AMENDMENTS TO THE DRAWINGS

REMARKS

Applicants submit this Amendment in reply to the Office Action mailed April 5, 2006.

Fig. 4

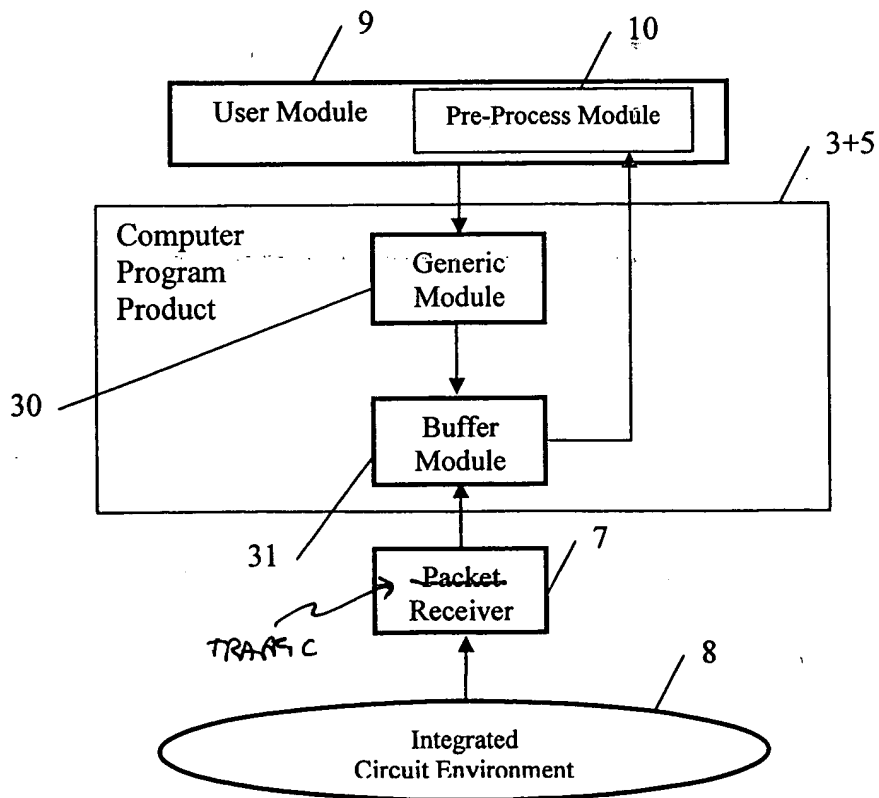
The attached sheets of drawings improve the clarity of FIG. 4. This change is not made in response to any rejection in the Office Action mailed April 5, 2006.

In the Amendment, Applicants amend the specification and FIG. 4 to improve clarity.
